**Re: Guelph Hydro Electric Systems Inc. ("Guelph Hydro")
Board File No. EB-2015-0073 – Technical Conference Topics Responses**

**TECHNICAL CONFERENCE RESPONSES OF
GUELPH HYDRO ELECTRIC SYSTEMS INC.
("GUELPH HYDRO")**

Table 8-VECC-75 – e-2– Load Profile with and without self-generation

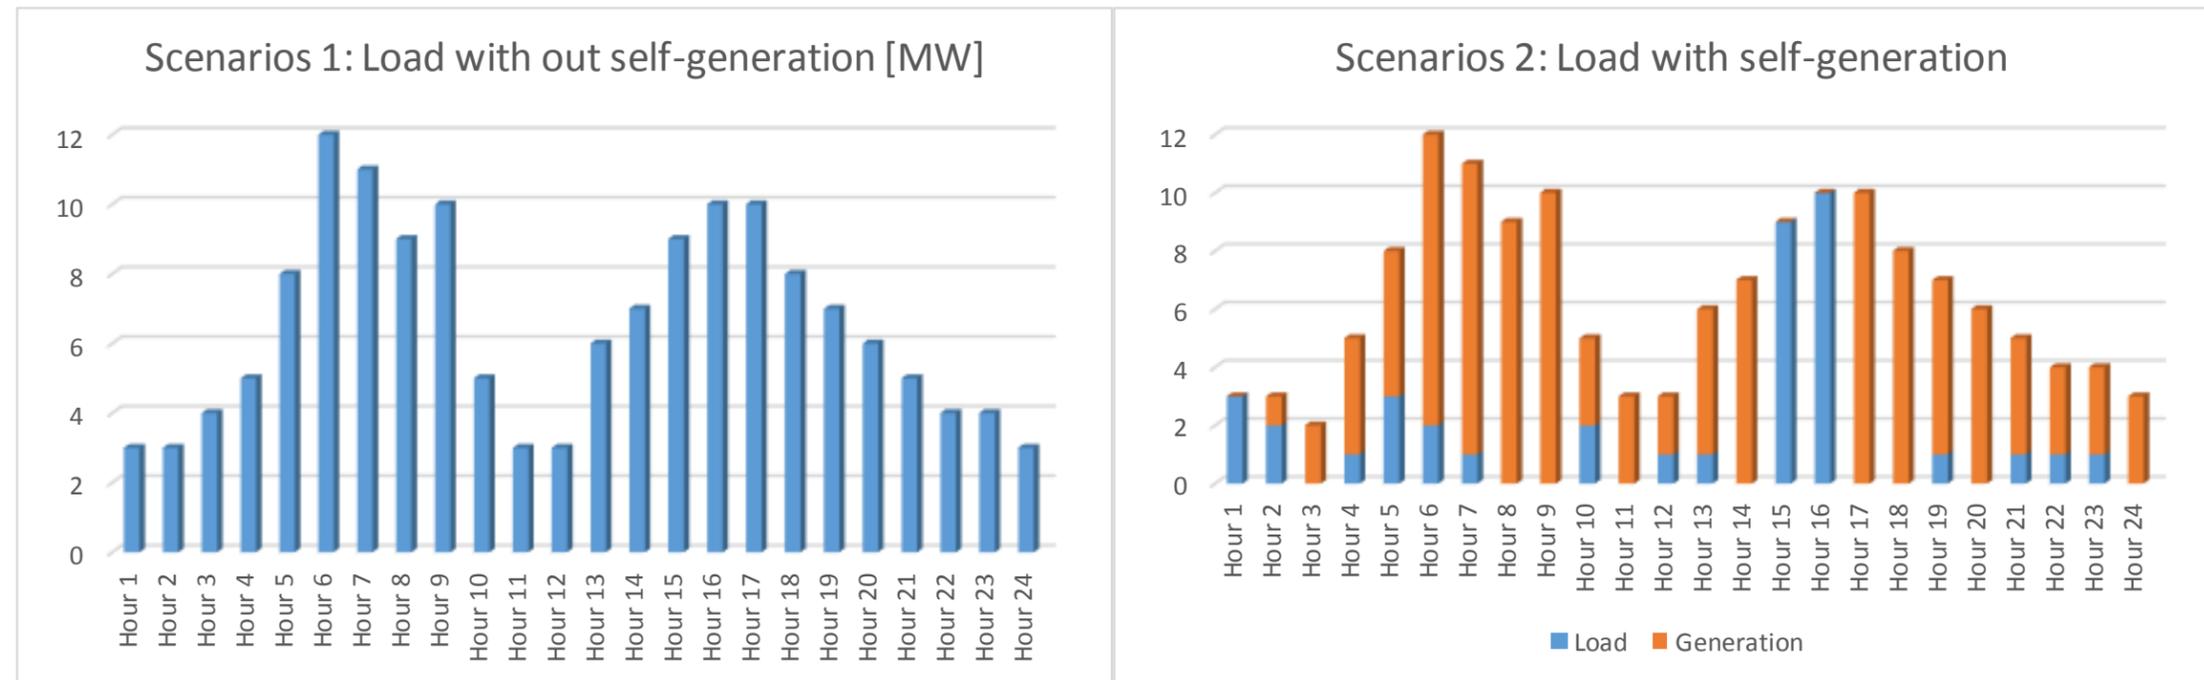
- e) **Please explain more fully why there would have been no additional revenue in 2014 if the existing Large Use customer had been billed under the proposed standby rates. Was there no month in 2014 when the maximum coincident demand of the delivered load plus the generation exceeded the maximum delivered load?**

The example shown above in Tale 8-VECC-75 illustrates the fact that the maximum coincident demand of the delivered load plus generation cannot exceed the maximum delivered load when the customer did not have self-generation.

In order to clarify more, Guelph Hydro presented below an example of load profile under the two scenarios: without and with self-generation.
